Video Products Technical Bulletin 30-2003-001

DATE: **January 8, 2003**SUBJECT: **REUSE L506 WHEN REPLACING THE A BOARD**

MODEL: **PVM-1942Q**
PVM-1943MD
PVM-1944Q
PVM-2042QM
PVM-2043MD
PVM-2044QM

Figure 1

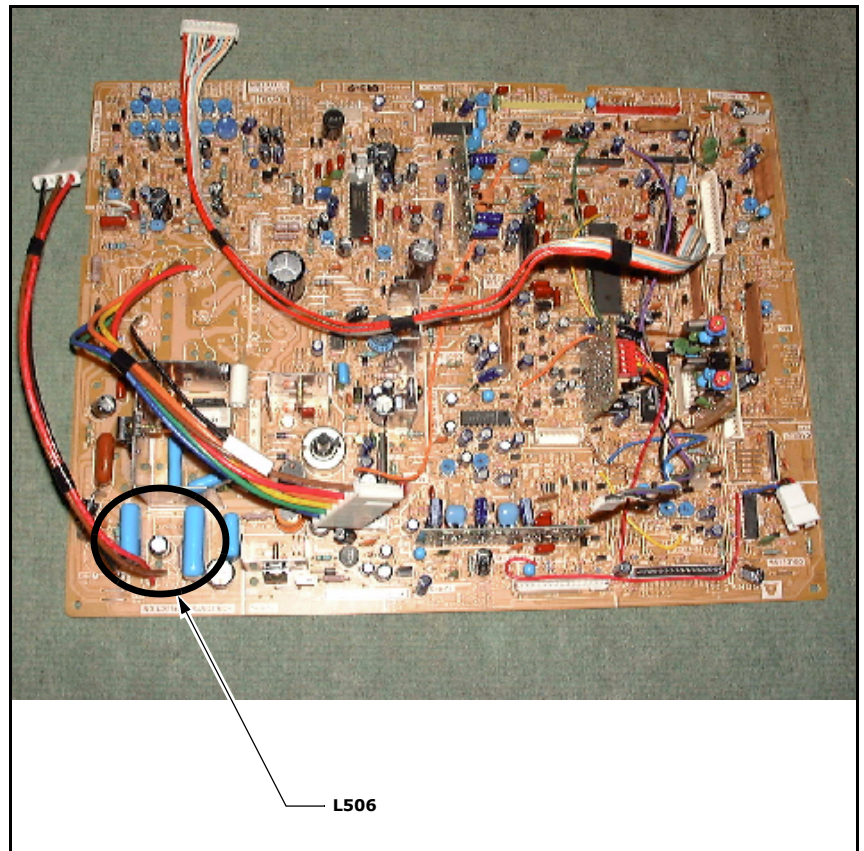
The micro-inductor mounted on the A board is no longer available. When replacing the board, reuse the micro-inductor from the previous board.

Remove L506 (3.9 mH micro-inductor) from the former A board and mount it on the new A board.
